What is the correct
terminology
for the media path in PoE?

P802.3bt TF Interim Mtg
Chicago/O'Hare, IL USA
March, 2018

GEOFF THOMPSON
GRACASI S.A./INDEPENDENT

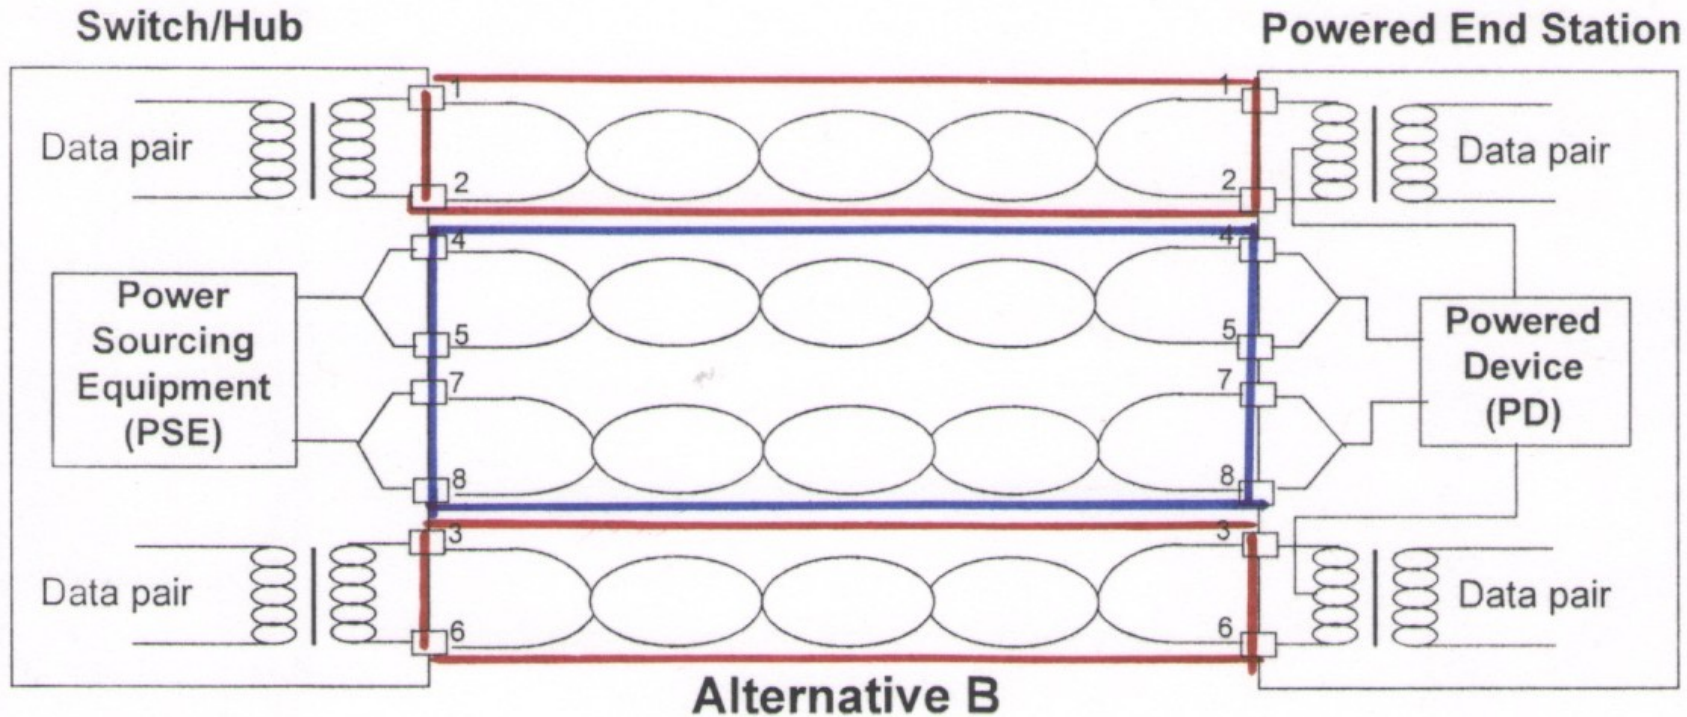
1.4.309 link section: The portion of the link segment from the PSE to the PD.

This was changed from the legacy definition by adding the word “segment”

i.e. “link” was correct, “link segment” is Incorrect.

In this instance, the link section is not a “portion” of the link segment.

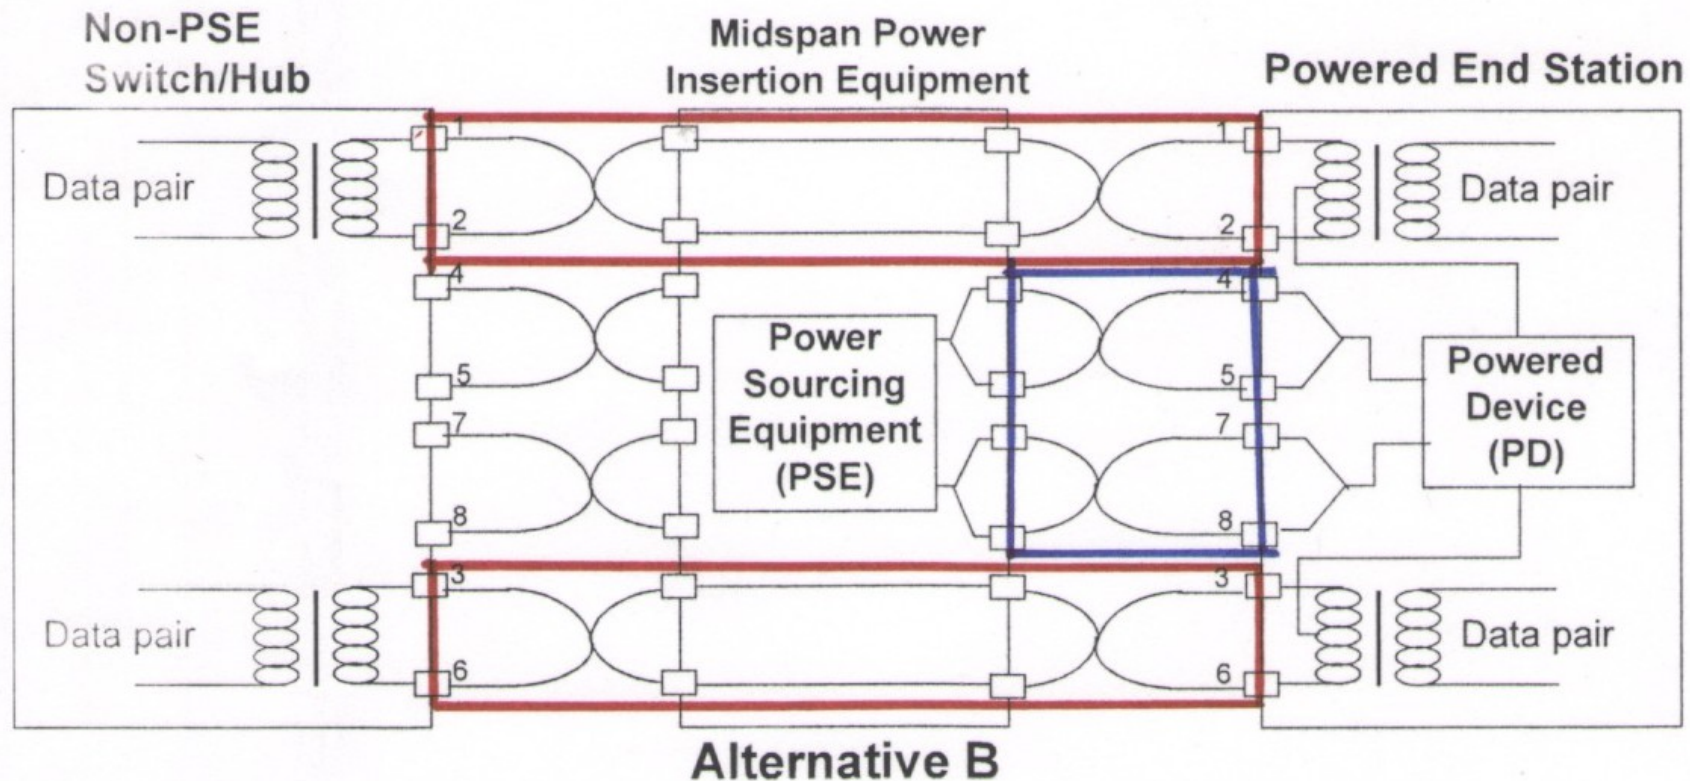
In this instance, the link section is not a “portion” of the link segment.
